Access Compliance Report

Public Rights-of-Way

(Curb Ramps)

Intersection ID: 10029121	Main Street: JAMES_BLAKENEY_AV	Cross Street: N/A	Location: SE
ADA ID: 643DCCCA41D8	Ramp Type: PerpDiag	Initial Pass/Fail: Fail	Overall Compliance: No
Codes/Mitigation Info/Possible Solution		Field Measurements/Component Compliance	
Severity Score: 37.5

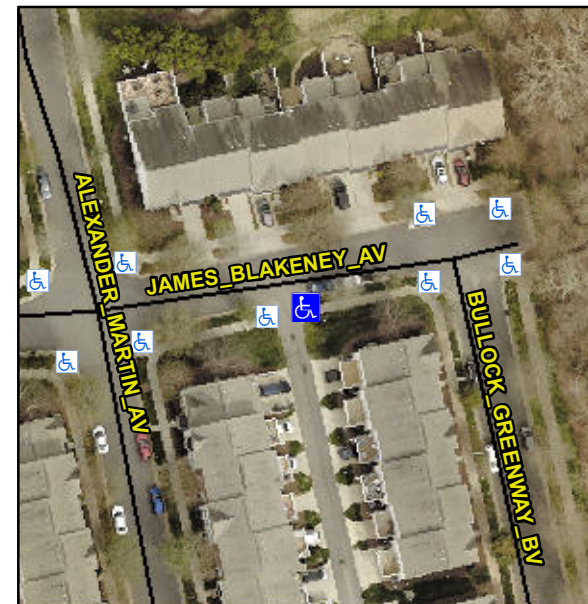
R304.2.2, R304.5.3

Compliance	Description	Data	Compliance	Description	Data
N/A	Ramp Length (in)	52.0	No	Ramp Slope (%)	10.1
Yes	Ramp Width (in)	49.0	No	Ramp XSlope (%)	8.0
N/A	Flare Type LT	N/A	N/A	Flare Type RT	N/A
N/A	Flare Slope LT (%)	N/A	N/A	Flare Slope RT (%)	N/A
N/A	Flare Traversable LT?	N/A	N/A	Flare Traversable RT?	N/A
N/A	Landing Length (in)	N/A	N/A	DWS Provided?	N/A
N/A	Landing Width (in)	N/A	N/A	DWS Contrast?	N/A
N/A	Landing Slope (%)	N/A	N/A	DWS Length (in)	N/A
N/A	Landing X Slope (%)	N/A	N/A	DWS Full Width?	N/A
N/A	Landing Curb? (Y/N)	N/A	N/A	DWS Offset (in)	N/A
N/A	Shared Landing?	N/A			
N/A	Gutter Ponding?	N/A	N/A	Gutter Slope (%)	N/A
N/A	Gutter Lip Ht (in)	N/A	N/A	Gutter X Slope (%)	N/A
N/A	Painted X Walk1?	No	N/A	Painted X Walk2?	No
	X Walk 1 Direction	To N		X Walk 2 Direction	To W
N/A	X Walk 1 Width (in)	N/A	N/A	X Walk 2 Width (in)	N/A
	X Walk 1 Slope (%)	3.0		X Walk 2 Slope (%)	0.6
	X Walk 1 X Slope (%)	0.5		X Walk 2 X Slope (%)	3.1

Remove & Replace Curb Ramp With Two New Directional Ramps or Equivalent.
